**Amendments to the Drawings:**

**Remarks**

FIG. 7

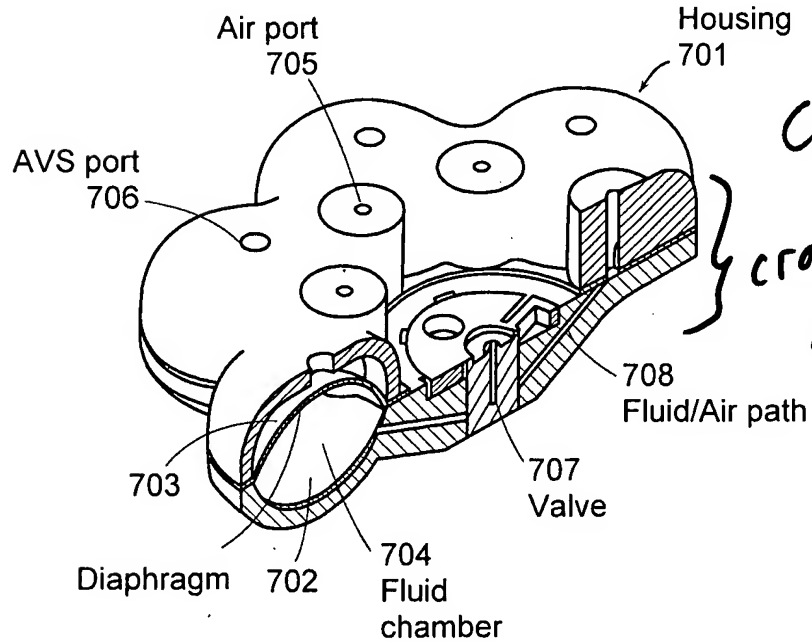
The attached sheet of drawings includes changes to Fig. 7. The attached sheet replaces the original sheet that included Fig. 7. In Fig. 7, cross-hatching has been provided to show a cross section.
